# City of San Antonio, Texas

Re: The Boulders at Canyon Springs (Enclave) Subdivision **MDP # 806-B**

**MASTER DEVELOPMENT PLAN FOR THE BOULDERS AT CANYON SPRINGS (ENCLAVE SUBDIVISION)**

**MDP # 806-B**

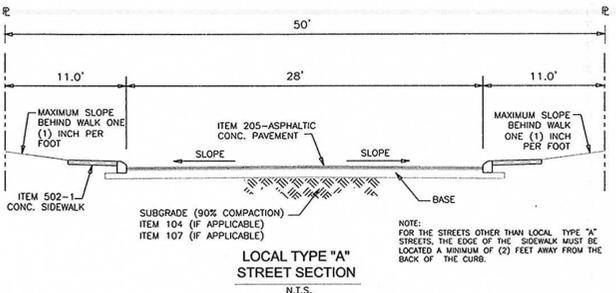
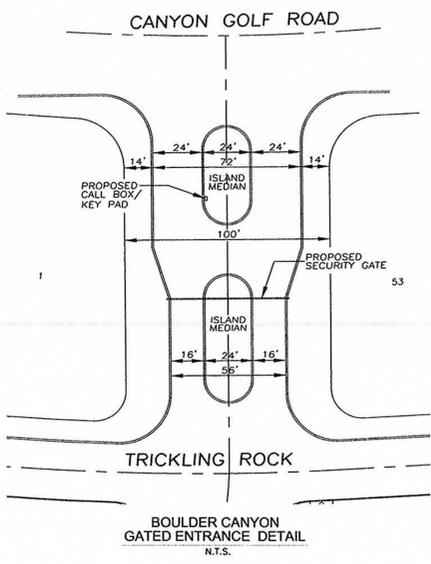
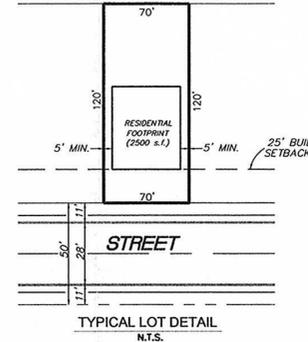
In consideration of public safety and convenience, excessive grades by reason of topography should be avoided in street layouts and arrangements.

- Additionally, a Water Pollution Abatement Plan or Contributing Zone Plan must be submitted to and approved by the Texas Commission on Environmental Quality (TCEQ) prior to construction.
- According to the Water Quality Ordinance # 81491, Section 34-913, buffering may be required. SAWS is in agreement with the developer to leave lot 12 block 13 and lot 15 block 22 as undeveloped lots for the preservation of the recharge features found on these two lots. These two lots shall be fenced for the public's protection.

- There is a high probability that the revised MDP that includes street stub-outs will change the direction of drainage and subsequently the drainage discharge points.
- It appears an underground system is proposed to accommodate the direction of water due to the street stub-outs.
- Given the steep slopes (terrain) it will be difficult to design adequate "sump" condition inlets to "pick-up" the storm water. The possibility of additional underground storm water may be required.
